<b>Subject:</b>  CHECK ENGINE LIGHT ON WITH DTC P0421	<b>Bulletin No:</b> 01-016/15
	<b>Last Issued:</b> 08/04/2015

Catalyst monitor function explanation

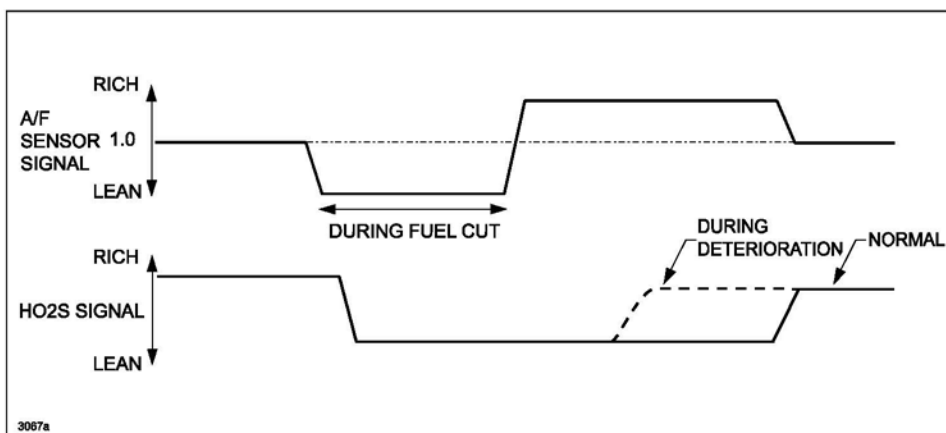
Some vehicles may experience the check engine light on with DTC P0421:00 (Catalytic converter system) without experiencing poor engine performance or misfire (Mitsubishi PCM only).

This is caused by improper control logic of the PCM that may detect false error of the A/F sensor, resulting in false detection of P0421. To correct the problem, the control logic of the PCM has been changed.

- The PCM monitors the oxygen storage amount proportional to catalytic converter purification characteristic.
- The PCM starts to monitor after recovery (fuel injection starts) from fuel cut control.
- The PCM temporarily changes the target air/fuel ratio to rich at fuel cut recovery, and detects the response time until the HO2S output signal outputs the voltage on the rich side.
- If the catalytic converter purification characteristic deteriorates, the amount of the time until the HO2S detects the voltage on the rich side is shorter compared to the normal purification characteristic as shown. The PCM detects a catalytic converter malfunction using this characteristic.
